Subject: **FCC Class II Permission Change Request for FCC ID: 2ATEV-BL1206-P**

This is to request a Class II Permission Change Request for FCC ID: 2ATEV-BL1206-P, originally granted on 2020/08/11

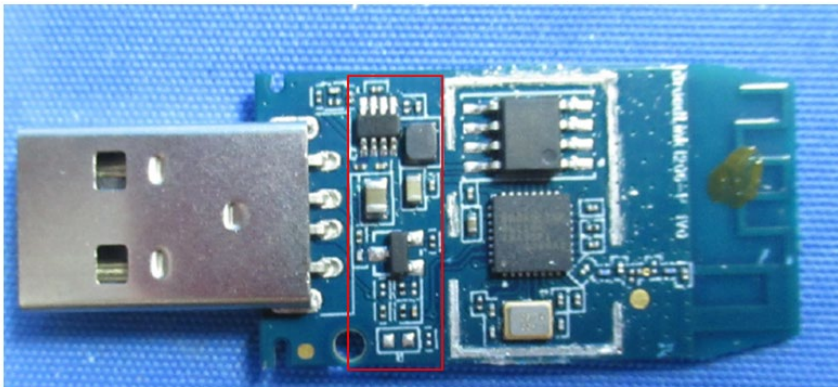
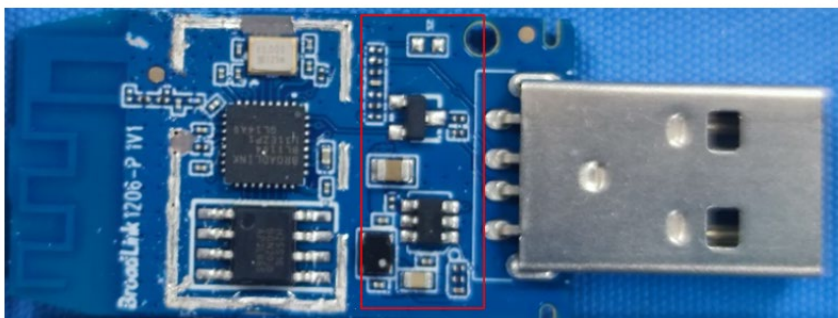
The DCDC used on 1V0 is MP2318, and the DCDC use on 1V1 is SGM61410. Because the DCDC has been changed, so the peripheral circuits are changed too.

Before(1V0):

Now(1V1):
